Product Advisory (PA)

Subject: Change of the standard interior label of Renesas Electronics

Publication Date: December 1, 2022

Comparison before and after change for legacy INTERSIL products

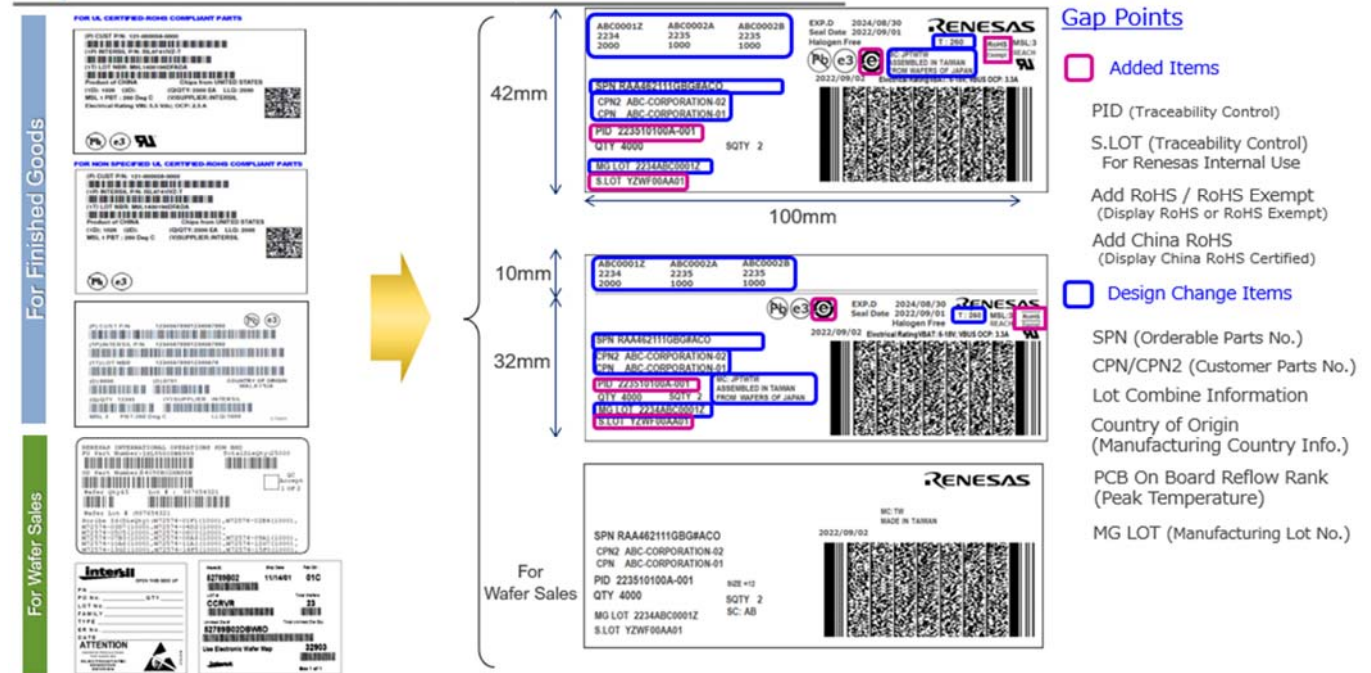
Gap Points Current and New / Ex-ISL

Comparison before and after change for legacy IDT products

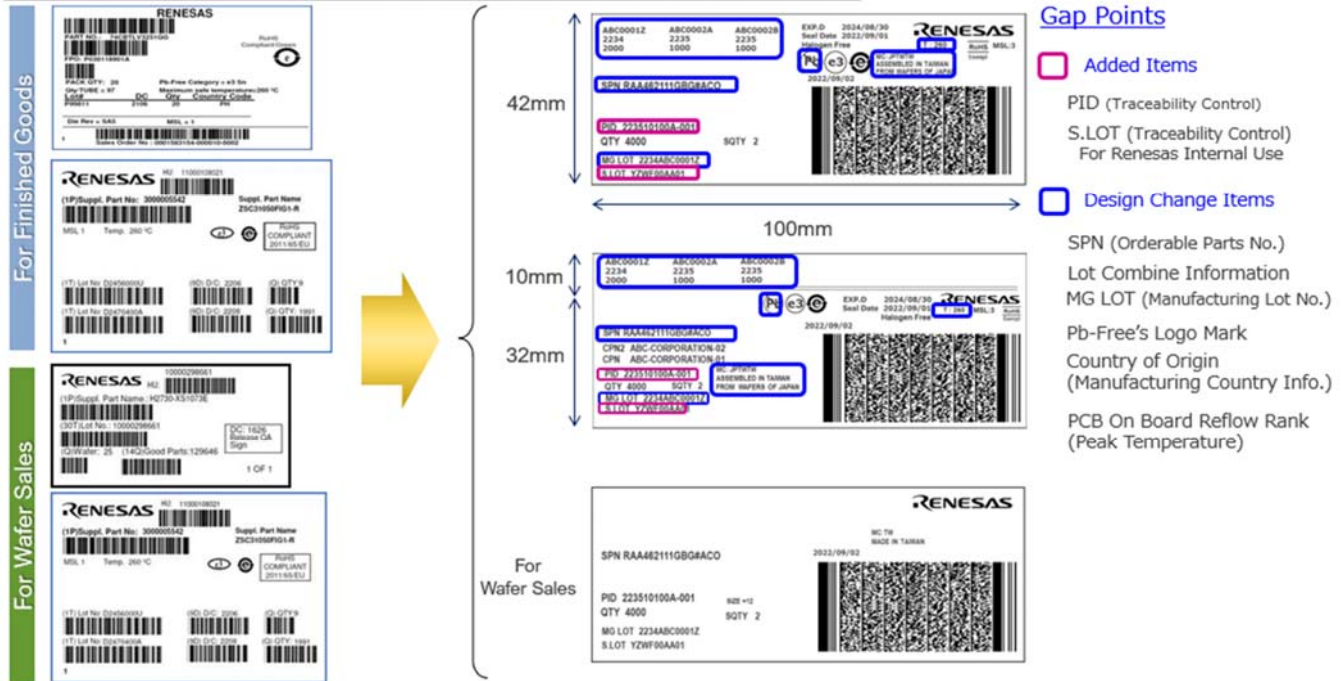
Gap Points Current and New / Ex-IDT

Comparison before and after change for legacy DIALOG products

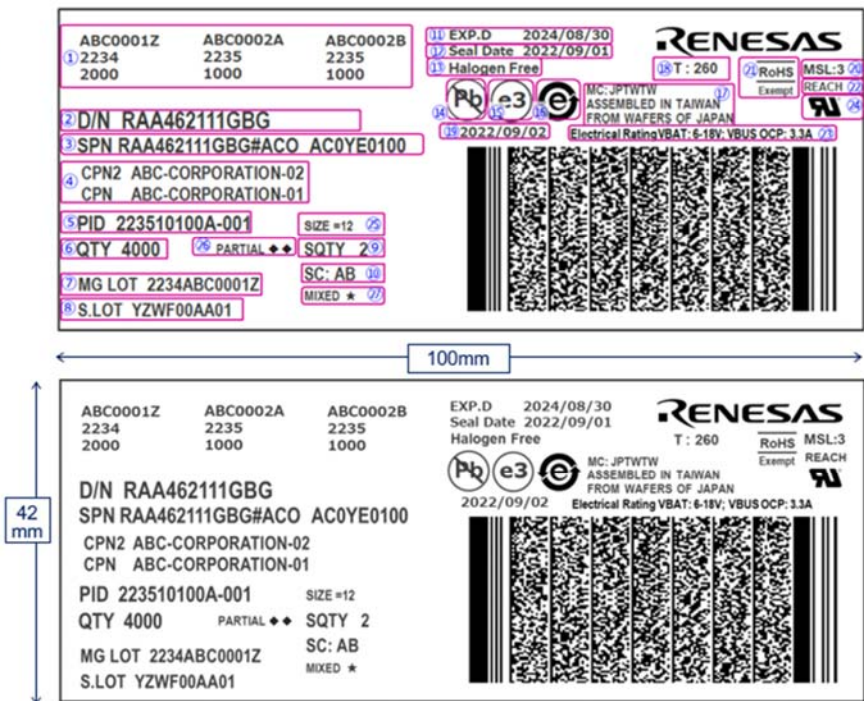
Gap Points:

- **Added Items**
 - PID (Traceability Control)
 - EXP. Date (Traceability Control)
 - For Renesas Internal Use
 - S.LOT (Traceability Control)
 - For Renesas Internal Use
- **Design Change Items**
 - Renesas Logo Mark
 - SPN (Orderable Parts No.)
 - CPN/CPN2 (Customer Parts No.)
 - MG LOT (Manufacturing Lot No.)
 - Lot Combine Information
 - Country of Origin (Manufacturing Country Info.)
 - PCB On Board Reflow Rank (Peak Temperature)
 - SC (Test Supplier Code)

Comparison before and after change for legacy RENESAS products

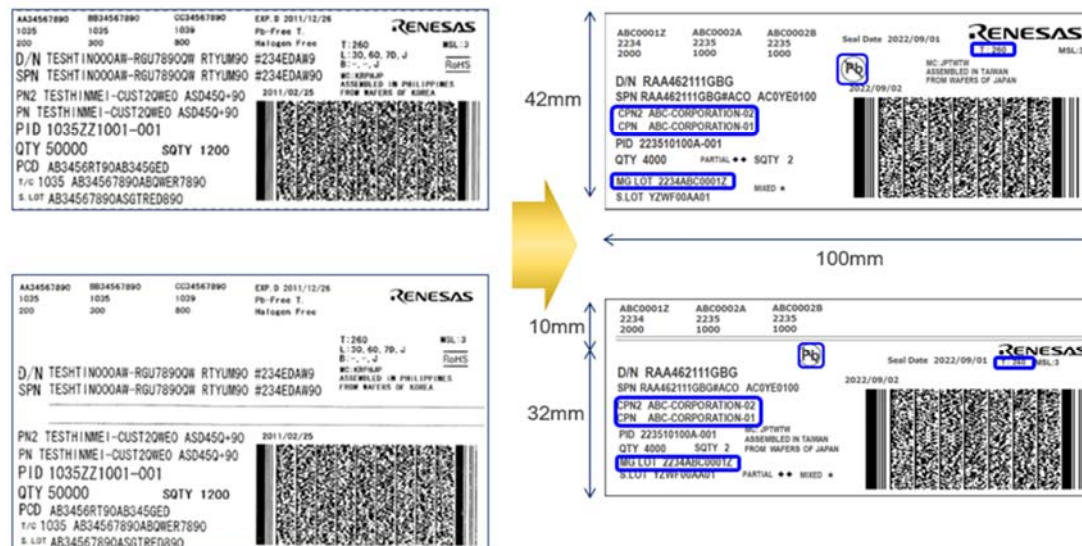
Gap Points

☐ Design Change Items

- Pb-Free's Logo Mark
- PCB On Board Reflow Rank (Peak Temperature)
- Customer Parts No. (Display Name Change)
PN/PN2 => CPN/CPN2
- MG LOT (Display Name Change)
T/C => MG LOT
- PCN (Deleted Item)
